SNS-OPM-ATT 2.B-10.a.
Unreviewed Safety Issue (USI) Evaluation Form

I. Title of USI Evaluation: BL11 and BL 1 PPS Logic Modification for Primary Shutter Control

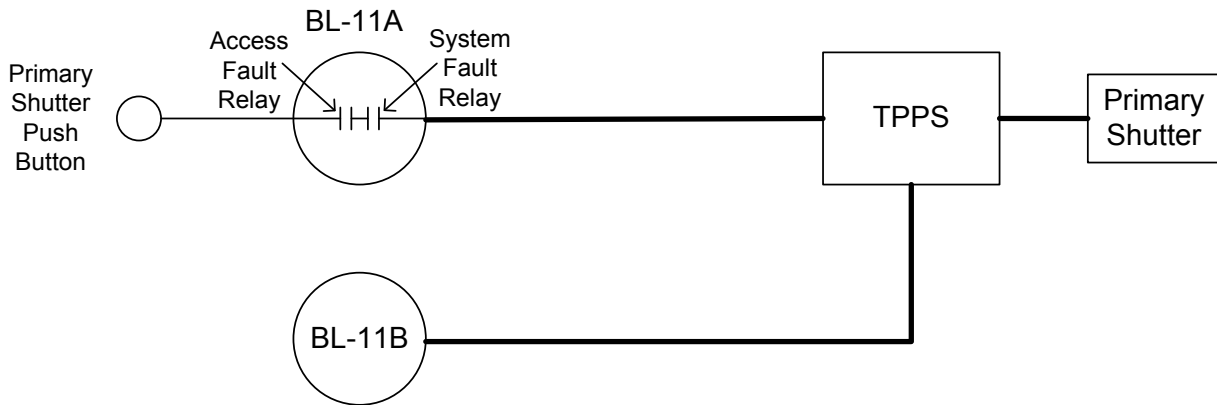
It is intended for the control logic to prevent the Primary Shutter from opening if access or system fault conditions exist. IPPS control logic for BL 11A includes access faults and system faults in the PLC logic chain of required conditions that must be met in order to issue an open shutter command to the Primary Shutter when the control button is depressed. The weakness identified in the BL 11B control logic is that the access faults and system fault are not part of the logic chain of required events to be satisfied in order to open the Primary Shutter. This weakness allows for the possibility that an open command could be issued and transmitted to the Primary Shutter by depressing the control panel button when a fault condition persists within the BL 11B control logic.

The present configuration is depicted in the figure below that shows the Access Fault and System Faults depicted as relays (note: although depicted in the figure as relays, the BL 11A logic is implemented with PLC logic, not physical relays) within the BL-11A control logic where none exists within the BL 11B control logic. The Primary Shutter “open” push button is located in the BL 11-A logic chain that can be thought of as the *Master* signal chain. The BL-11B signal is provided to the Target Personnel Protection System (TPPS) logic that requires a safe (high) signal from both BL 11A and 11B. As can be seen in the diagram below, either an Access Fault or a System Fault within BL 11A prevents the push button open command from reaching the TPPS. However, in the current configuration, BL 11B Access and System Faults are not incorporated in the open command logic. Faults from both beam lines are included in the TPPS close command logic. However, when the Primary Shutter reaches the closed position due to an access or system fault, the close command goes away.

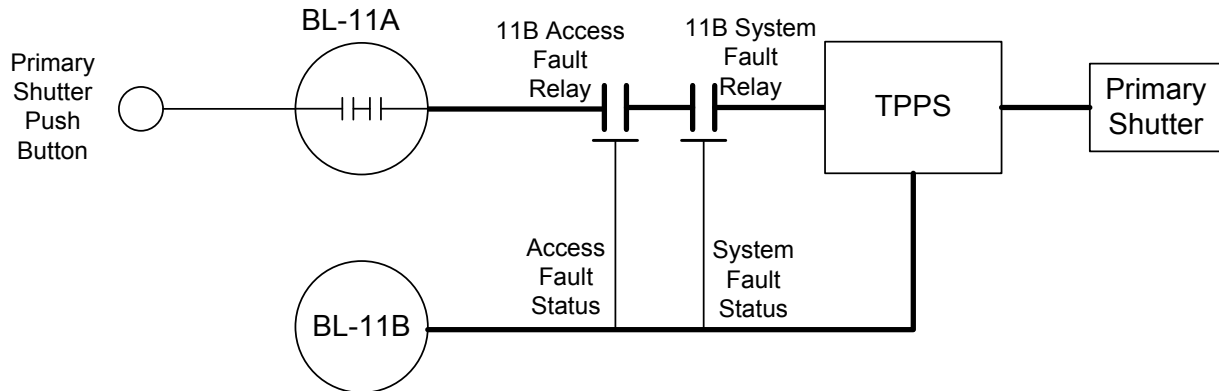
The proposed modification is to add relay logic with physical hardware relays to interrupt an open shutter command should Access or System Faults exist on BL 11B. The proposed modification is depicted in the figure below. Two physical hardware relays will be installed in the BL-11A master command chain for opening of the Primary Shutter. If either an Access or System Fault exists in BL 11B, the respective relay will create an “open circuit condition” effectively preventing the open request from reaching the TPPS.

The relays will be physically located in the TPPS-Cab07 control cabinet as shown on modified drawings 109090201-R8U-8700-A117, Rev1 and 109090201-R8U-8700-A105, Rev1. The relays will add the fault statuses from BL-11B to the Primary shutter “Open” request signal that is generated at BL-11A and sent to TPPS.

**Shutter Travel Required
To Expose Streaming Gap
During Opening
(Lowering)**

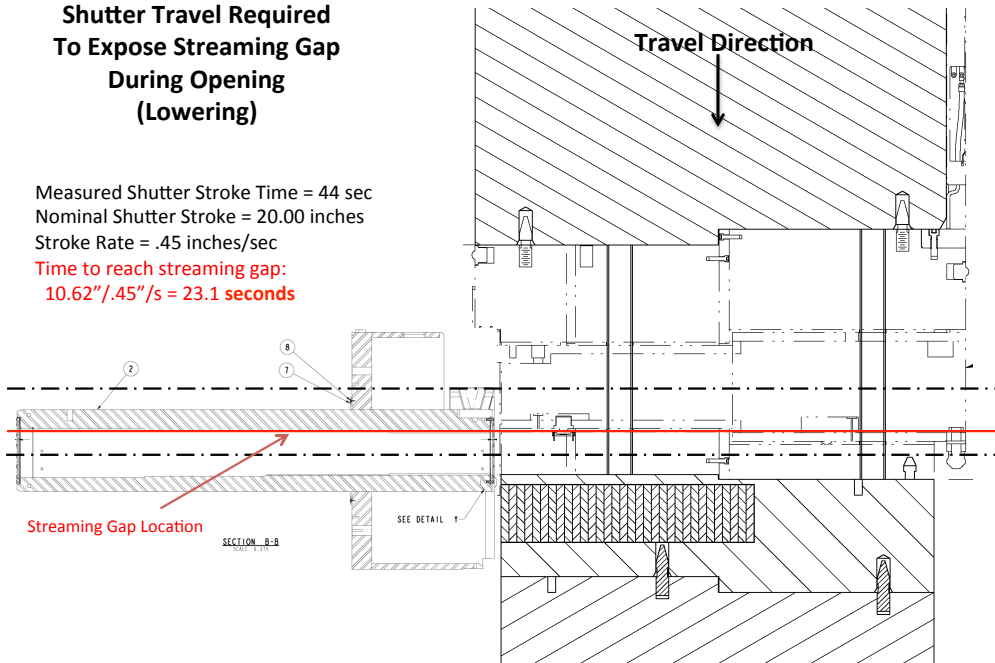
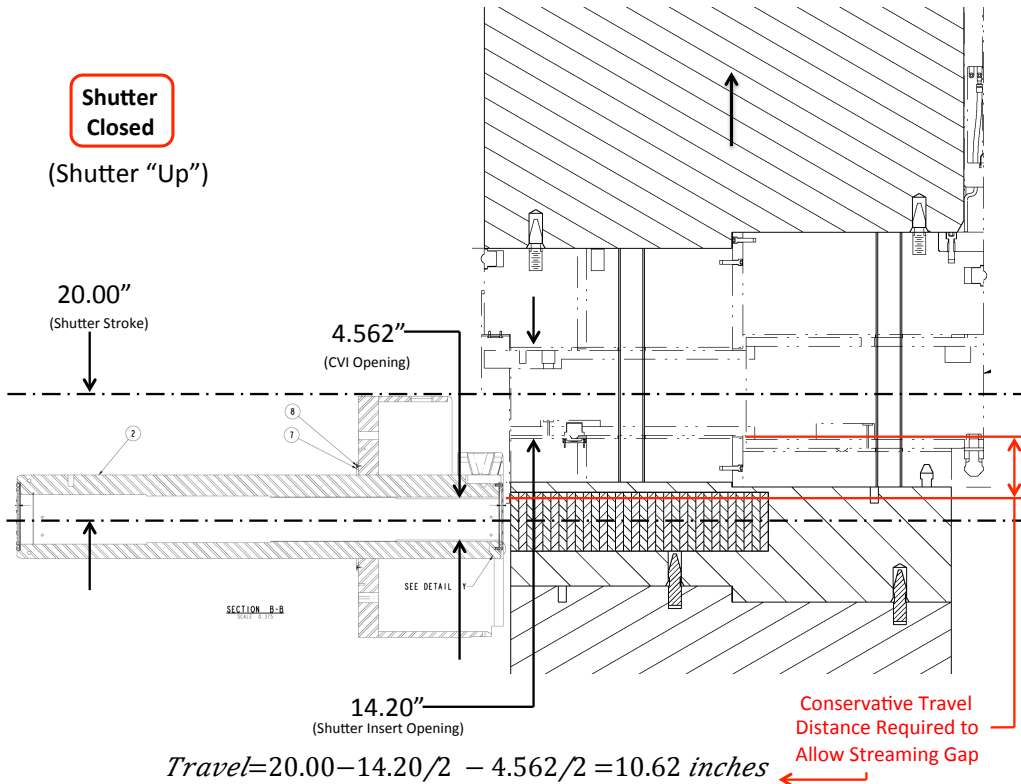
Recently measured travel times for the BL 11 Primary Shutter showed 44 seconds from fully closed to fully opened, and 68 seconds from fully opened to fully closed.² The Primary Shutter has a stroke (distance of travel) of 20 inches from fully open to fully closed. Examination of dimensions provided in the Primary Shutter, Shutter Insert and Core Vessel Insert drawings conservatively indicate that the shutter must move 10.5 inches from the fully closed position before line of sight streaming through the Shutter Insert could occur³. If we assume constant travel speed, we can calculate the time required from the issuance of the open command before streaming could start to occur as follows:

Therefore, we see that the Primary Shutter would not fully open, however, it could begin to partially open at 23.1 seconds allowing a streaming path as the shutter moved from 10.5 to 13.6 inches from the closed position over the time frame of $30 - 23.1 = 6.9$ seconds.

Based on the above assumptions, we could estimate open streaming path could be open for $6.9 + 10.5 = 17.4$ seconds.

Measured Shutter Stroke Time = 44 sec
 Nominal Shutter Stroke = 20.00 inches
 Stroke Rate = .45 inches/sec
 Time to reach streaming gap:
 $10.62" / .45"/s = 23.1 \text{ seconds}$
